Architect's Change Proposal Request

Project: New Deer Park City Hall

CPR Number: **CPR 54**

MECHANICAL 1ST FLOOR PLAN

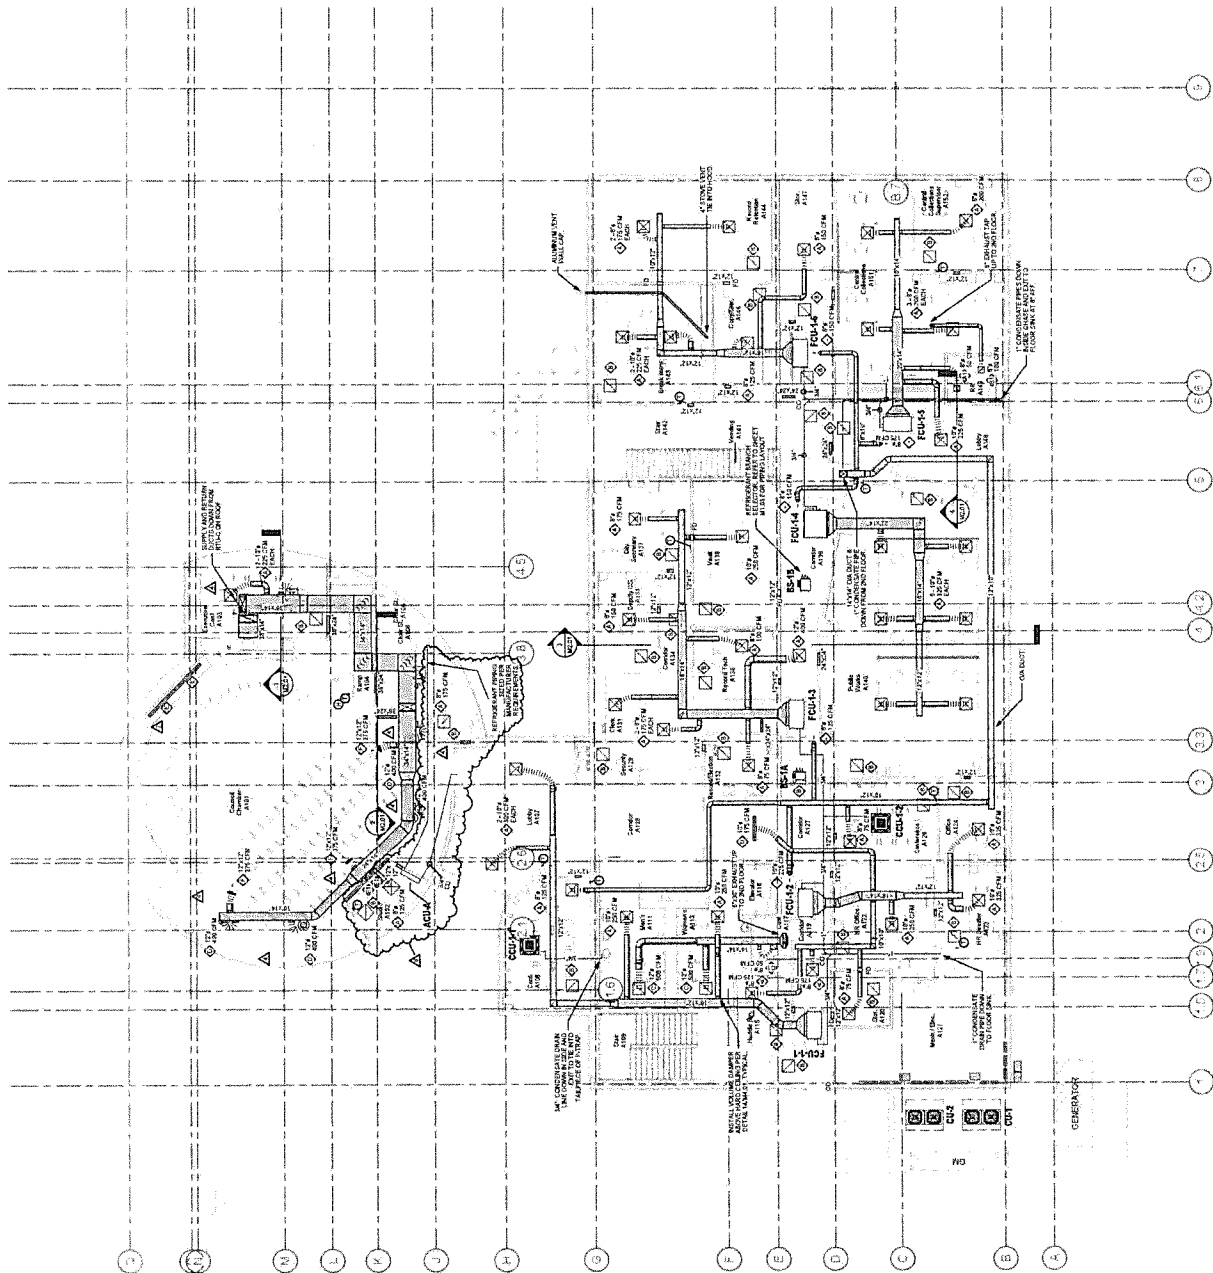
Provide all materials, equipment and labor to install new AC system to Studio A102 to supplement cooling to the room as per the attached drawings M1.01, M1.02, M3.00, E3.01, E3.02 and E6.01.
